REALARCHITECTURE LTD
2899 N. Speer Blvd. Suite 102
Denver, Colorado 80211
www.realarchitecture.com

August 31, 2020

The following letter and revised drawings respond to your review and comments for 53rd and Tennyson Row project at 4301 W. 53rd Ave, Log number PRC2020-00005. Responses are listed below in **red**. Please call or email if you have any questions or require additional information.

FIRE
ANALYSIS

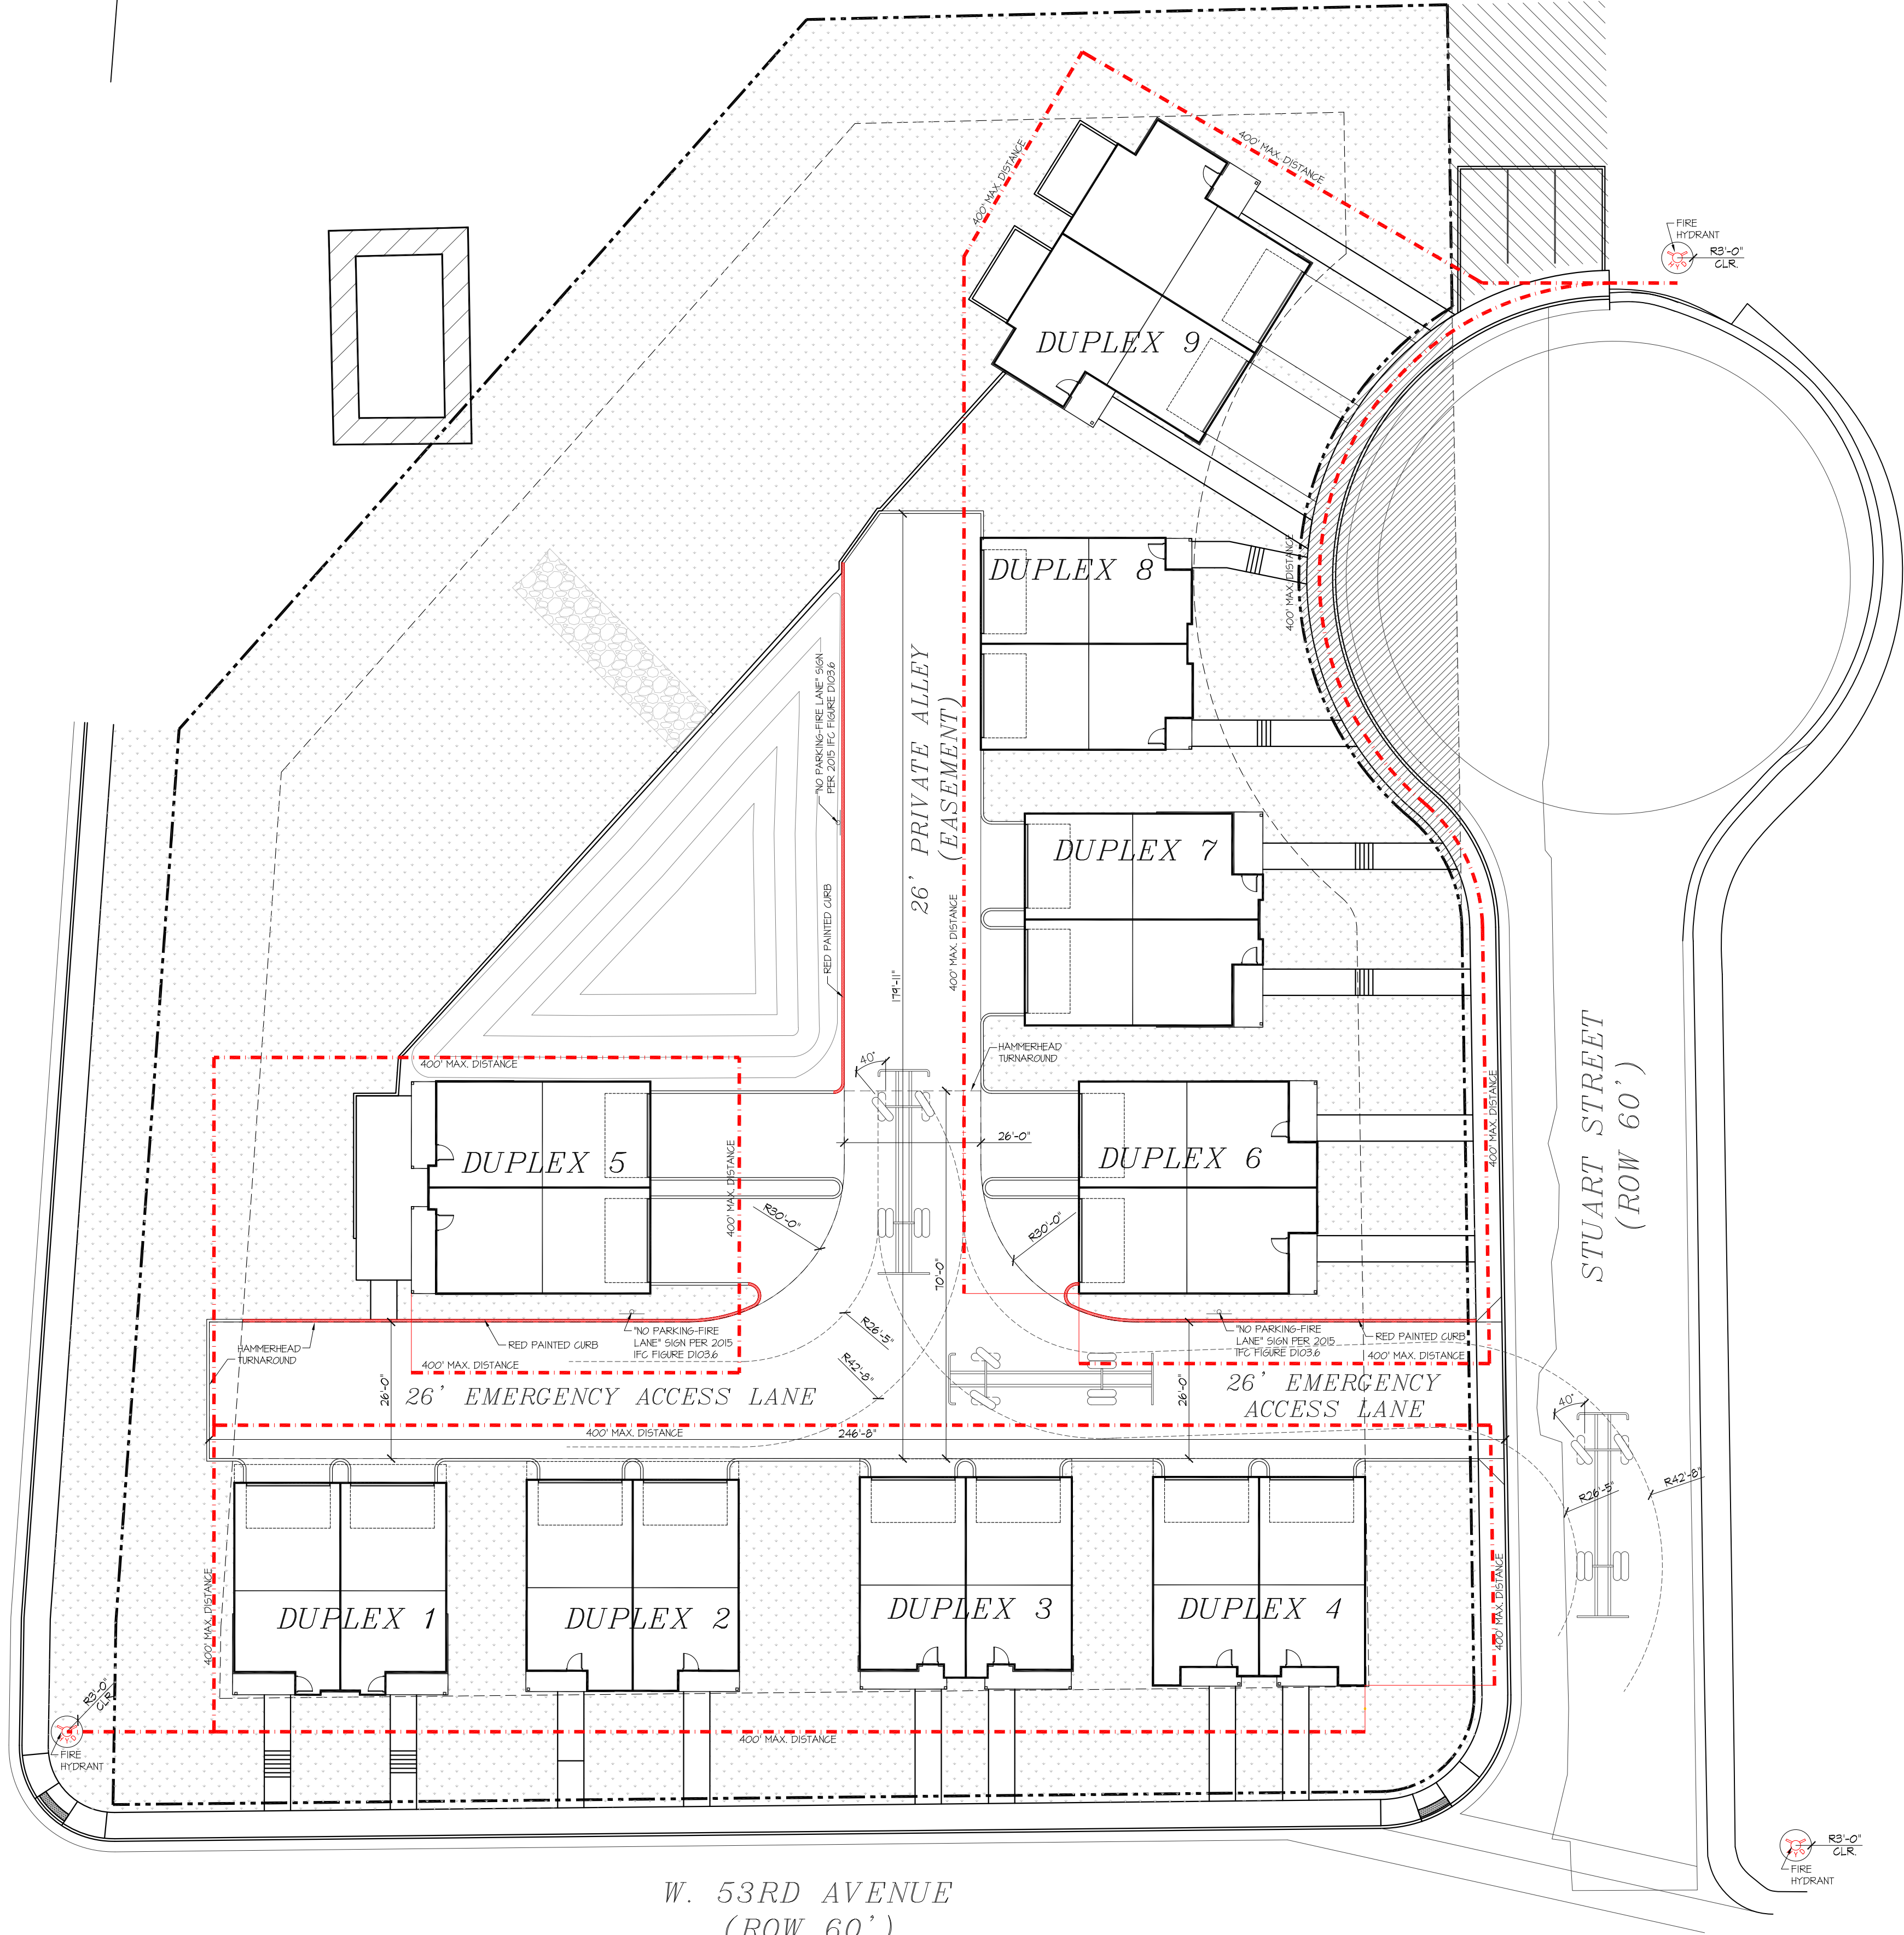
5. We typically require a drive path analysis showing that our fire apparatus will be able to easily maneuver along fire apparatus access roads.
Please use the attached turning radius template and provide the specifications used in your analysis on the plan. Please provide a turn path analysis (autoturn exhibit) showing that we will be able to navigate the private alleys and utilize them for turning around.

6. Fire apparatus access roads shall be delineated on the site plan as emergency Access Lanes and shall be marked with a no parking fire lane sign and curbs shall be painted red. See areas highlighted in red below.
- a. Fire apparatus access roads shall be marked with permanent NO PARKING-FIRE LANE signs complying with Figure D103.6. Signs shall have a minimum dimension of 12" wide by 18" high and have red letters on a white reflective background.

Included in the resubmittal is a fire analysis plan showing the drive path and turning radius per the provided template.

Included in the resubmittal is a fire analysis plan showing the fire apparatus access roads labeled as emergency access lanes and marked with no parking signs per the aforementioned requirements.

Included in the resubmittal is a fire analysis plan showing turn around requirements and dimensions.
